# **DEVELOPMENT APPLICATION ASSESSMENT REPORT**

DA2022/1343

Responsible Officer:	Gareth David
Land to be developed (Address):	Lot 34 DP 11374, 12 Collaroy Street COLLAROY NSW 2097
Proposed Development:	Alterations and additions to a dwelling house including a swimming pool
Zoning:	Warringah LEP2011 - Land zoned R2 Low Density Residential
Development Permissible:	Yes

Figure 1: Side boundary envelope breach of proposed additions on the eastern elevation shown in pink

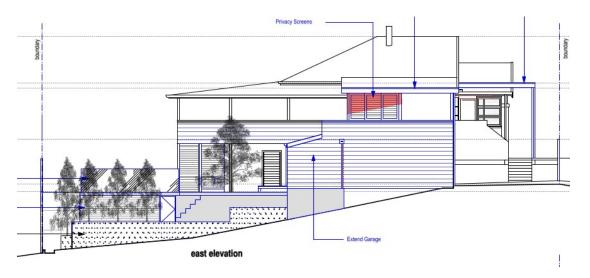
Clause B3 of the WDCP 2011 stipulates that buildings are to be projected at 45 degrees from 4m above the existing ground level, measured from the side boundaries. The proposed additions encroaches into the side boundary envelope along the eastern elevation as depicted in figures 1 below.

The non-compliance relates to a minor portion of privacy screening and open balcony roof.

The apparent size of the proposed development is not inconsistent with the size and scale of the existing dwelling and surrounding development throughout the immediate locality. The proposal will be well below the required height limit and ridge of the existing dwelling, present as two storeys from the street and will maintain the overall character of the existing dwelling as viewed from the streetscape. The non-compliance relates to an open balcony and privacy screen and would not result in unreasonable bulk and scale.

The application has demonstrated that the proposal will not have an unreasonable impact with regards to solar access. The proposed envelope non-compliance would not result in unreasonable solar access impacts.

The proposed balcony will remain a predominately open structure and will be well below the ridge of the existing dwelling. This retains a stepped design to respond to the topography of the land.

Having regard to the above assessment, it is concluded that the proposed development is consistent with the relevant objectives of WDCP and the objectives specified in s1.3 of the Environmental Planning and Assessment Act, 1979. Accordingly, this assessment finds that the proposal is supported.
